STAFF REPORT: 12/13/2023 REGULAR MEETING
APPLICATION NUMBER: HDC2023-00146

ADDRESS: 1515 SEYBURN

HISTORIC DISTRICT: WEST VILLAGE

SCOPE: REPLACE 2 REAR WINDOWS, REPAIR EXISTING WINDOWS

Figures 1 by Applicant: showing location of proposed modified window (see red circle above).

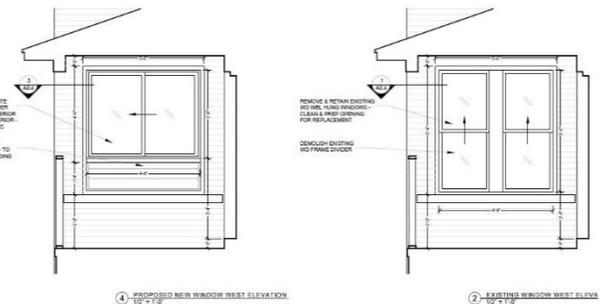
The work also proposes the replacement of a pair of double hung windows, located at the rear elevation near the rear deck entrance. This proposed replacement is to accommodate an interior kitchen layout with a countertop that would be located inside the window. The original windowsill would be left in place, while the pair of double hung windows and the wood mullion would be replaced with a pair of aluminum-clad wood Marvin Ultimate French casements, with no divided lights, and have their own, thinner vertical mullion, and new infill wall with wood paneling below the window to the existing sill to close the remainder of the window opening. The brick work would remain untouched, and the original sash held on site in storage for potential future re-installation.

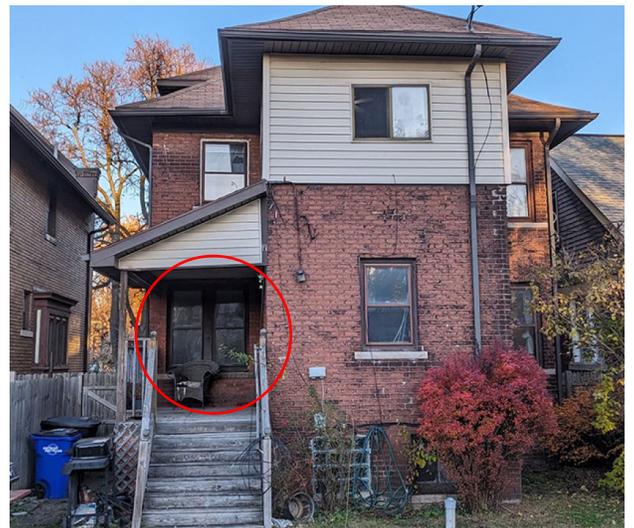
Figures 2&3, by Applicant: showing existing conditions (right) and proposed condition (left). Note that the applicant has now modified the application so that previously proposed slider window would be replaced with a pair of casements and the proposed vinyl siding, would instead be wood panel below the new set of casements. The center mullion is still proposed for removal.

- Staff has the opinion that some alteration of the rear sash may be appropriate at this secondary elevation. However, the proposed removal of the center mullion does not appear to be necessary to reasonably achieve the desired interior conditions and thus should be preserved. It should be noted that interior reconfigurations of historically protected buildings cannot compel the alteration of distinctive exterior features under the Standards. Staff believes the robust vertical mullion is distinctive and important to the overall historic character.

- The alteration to the rear windows shall be redesigned to retain all exterior woodwork, (excepting the sashes), including the center mullion, stone sill and brick opening in their current position, while allowing infill of the new windows over wood panels in the resulting two openings. The removed sash shall be stored in the building for future reinstallation.
- The two separate infill windows shall be of casement or double-hung operation and made of wood or aluminum-clad wood materials.
- The two separate infills below the two new windows shall be designed in wood and painted according to HDC guidelines.
- The applicant provides HDC staff with an updated proposal drawing for review and approval of these conditions before work begins.
